**LEVEL III SITE PLAN REVIEW**  
 CONDITIONS OF APPROVAL  
 (See Approval letter dated March 17, 2015 from the City of Portland)

PROJECT	midtown PORTLAND, MAINE
SHEET TITLE	OVERALL SITE PLAN
CLIENT	FEDEQ DV001, LLC
DESIGNED BY	BEK
CHECKED BY	SRB
FILE NAME	3062-SITE
DRAWN BY	LA
DATE	OCTOBER 2014
SCALE	1" = 40'
JOB NO.	195350127
SHEET	C-2.0

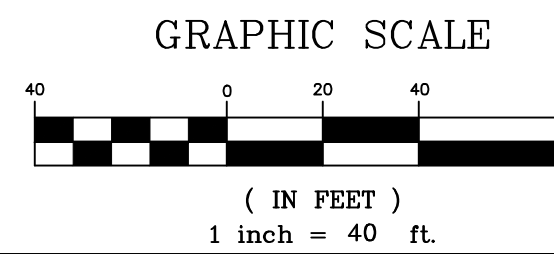
- The configuration of the sidewalk with the indented parking area in front of Midtown 4 will be revised to provide the pedestrian environment along the Elm Street sidewalk. A re-design of this Elm Street frontage is required to comply with the B-7 Design Principles and Standards. Therefore, the on-street parking bay shall be shifted to the south so that it does not constrain the sidewalk in front of building Four. In addition, the sidewalk and cutting must be implemented in a manner that will match an MDOF approved. City plan to modify Elm Street to eliminate that narrow sidewalk at the corner of the Tassier Joe's Building.

- The ramp and landing system on the NE corner of Elm Street - Somerset Street must be revised to achieve ADA compliance and to provide quality pedestrian street crossings and a quality pedestrian environment along Elm Street and Somerset Street. The new configuration is to be reviewed and approved by the Traffic Engineer and Planning Authority.

- The curb extension on the north side of Somerset Street near the News must be extended to the beginning of the nearest on-street parking space along Somerset Street.

- That the site plan shall be revised depicting details of the Bayside Trail as having a minimum width of 16 feet.
- Applicant shall be responsible for all costs associated with the repair or reconstruction of the Bayside Trail when damaged or disturbed by applicant construction associated with the project.

- The final location of the hydrant to be relocated along Lancaster street shall be reviewed and approved by the Fire Department.
- A Dumpster is proposed to be placed inside of Midtown Three for the trash holding area. Although this building will be provided with a full sprinkler system, a two-hour separation between this space and the remainder of the building shall be required.
- The new proposed curb cut and access off Elm Street to the small side of Midtown Four must be a minimum of 16' wide for fire access. The final plans shall be revised showing the required signage and striping on the driveway indicating Fire Lane NO PARKING for review and approval.

- The new proposed curb cut and access off Elm Street to the small side of Midtown Four must be a minimum of 16' wide for fire access. The final plans shall be revised showing the required signage and striping on the driveway indicating Fire Lane NO PARKING for review and approval.
